CITY OF AVON LAKE ZONING BOARD OF APPEALS

**MARCH 26, 2025
COUNCIL CHAMBERS – 150 AVON BELDEN ROAD
7:00 PM**

REPORT – ZBA CASE 25-3

TO: Avon Lake Zoning Board of Appeals
FROM: Austin Page, Planning & Zoning Manager
SUBJECT: CAV 25-3 (AREA VARIANCE – 33128 Lake Rd)
MEETING: March 26, 2025

Figure 2: Applicant Provided Site Plan – CAV 25-3

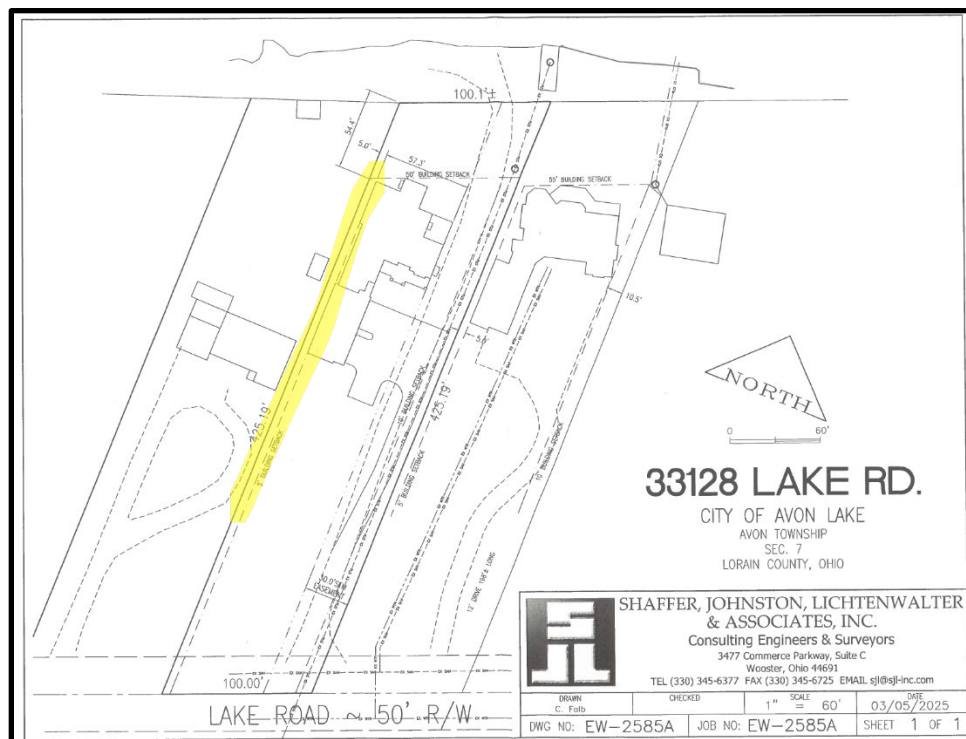
Because of the easement, the applicant is proposing the construction of a new single-family residence that would reduce the westernmost side yard setback from 10' to 5'. With the R-1A zoning, code requires a 50' front setback, 35' rear setback and 10' side yard setbacks. The front, rear, and easternmost side yard setback adheres to code and are not impacted by this variance request.

There are no issues or concerns with the height or façade of the proposed home.

Figure 2: Site Plan – Applicant Provided – CAV 25-5

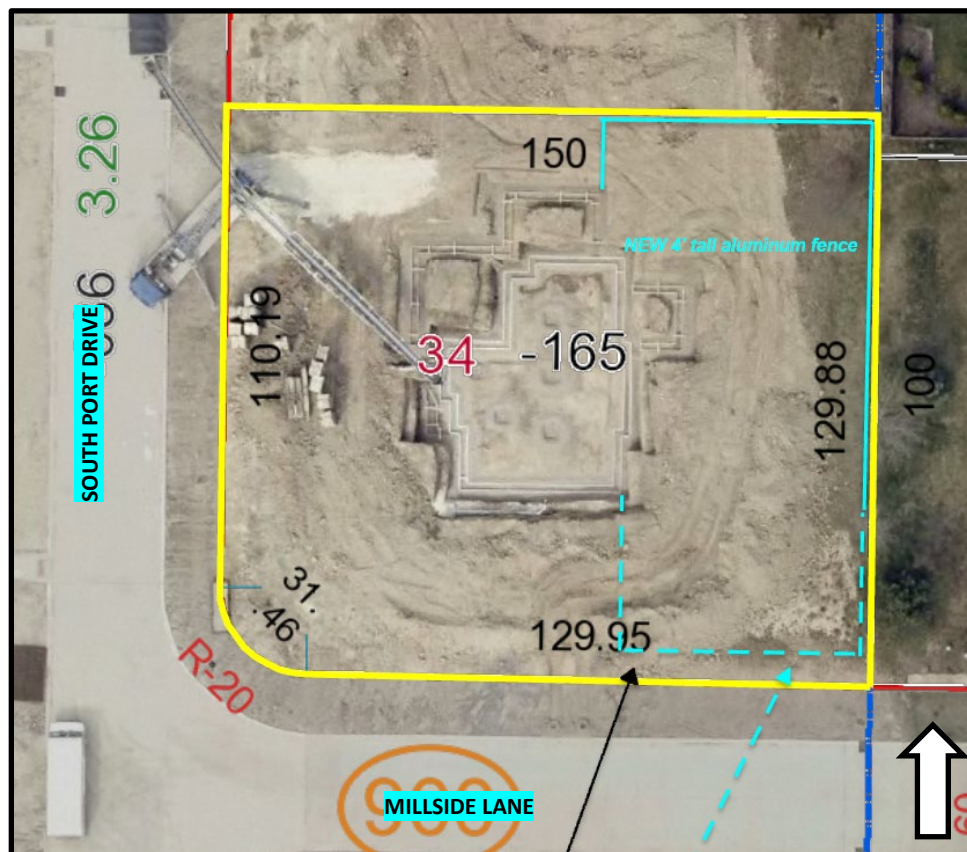
The proposed fence is shown one foot off the sidewalk. It is normal to have fences placed at least 2' off the sidewalk to provide adequate usage and spacing for pedestrians on the sidewalk. Placing the fence this close to the sidewalk may create an issue and provide for unsafe situations or conditions. The fencing is compliant in the side and rear yard but exceeds the maximum height requirement in the front yard by

one foot. The Community Development recommends that if the Board decides to grant the variance, they do so with the condition that the applicant adjust the fence to be at least 2' off the back of the sidewalk.
